OFFICE OF SURFACE WATER TECHNICAL MEMORANDUM 2009.02

SUBJECT: Release of WinRiver II Software (version 2.04) for Computing Streamflow from Acoustic Doppler Current Profiler Data

**Figure 1.** Velocity contour plot of a transect processed with side-lobe cutoff calculated as (a) 6 percent of mean beam depths, as in WinRiver versions prior to 2.03 and (b) with the new side-lobe cutoff calculated as 6 percent of the minimum beam depths.

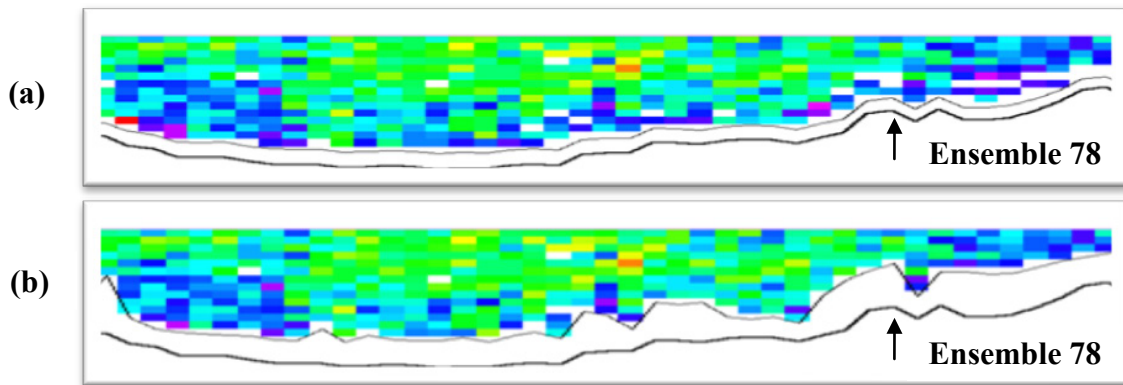
- 2. Change in Side-Lobe Cutoff Calculation.** For each ensemble, WinRiver calculates a depth below which velocities measured by the ADCP are not used due to possible errors caused by side-lobe interference. This depth is referred to as the side-lobe cutoff. In previous versions of WinRiver (2.02 or earlier) the side-lobe cutoff was calculated as 6% of the depth, computed as the mean of all valid beam depths for an ensemble (figure 1a). The new side-lobe cutoff is calculated as 6% of the shallowest beam depth in an ensemble (figure 1b). For example, the side lobe cutoff computed for ensemble 78 in figure 1 for prior versions of WinRiver II is 2.4 ft. The beam depths measured for this ensemble were 1.9, 3.5, 3.3, and 1.7 ft. The new side lobe cutoff, computed using WinRiver II version 2.03 and 2.04 is 1.6 ft. The change in the side-lobe cutoff may result in fewer valid depth cells in ensembles near sloping banks and in cross sections with irregular or rough streambeds. As a consequence, the middle (measured portion of the cross-section) discharge will decrease and the bottom (unmeasured or extrapolated portion of the cross-section) discharge will increase.

OSW has used the new version of WinRiver II to reprocess discharge measurements from Oberg and Mueller (2007) as well as other available measurements. Based on the discharge measurements reviewed to date, the new side-lobe cutoff has resulted in a median difference in discharge of +0.5 percent. The typical change in discharge was less than 1 percent. However, for about 4 percent of the discharge measurements reviewed the discharge changed by more than 5 percent. The largest changes were found for measurements made in shallow uneven cross sections that would typically be considered poor measurement sections. These cross sections are characterized by mean differences of beam depths for individual ensembles ranging from 17 to 32 percent.

*Measurements collected in the 2009 Water Year with a mean difference of beam depths in individual ensembles exceeding 15% or a mean number of valid depth cells per ensemble less than 4 must be reprocessed using version 2.04.*
